Rezoning Transportation Analysis

Petition Number: 2017-006 General Location Identifier: 02964110

From: Kelsie Anderson, PE Staff Reviewer: Rick Grochoske, PE

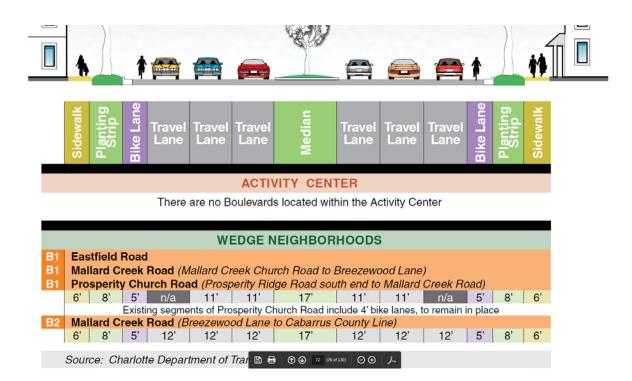
Eastfield Rd.'s proposed back of curb line needs to be located 38' as measured from its existing
centerline to accommodate the Boulevard section defined in the area plan (see below). This does
not include width that may be needed for turn lane(s). An additional 3' of widening may be
needed for a 3' buffer for the bike lane.
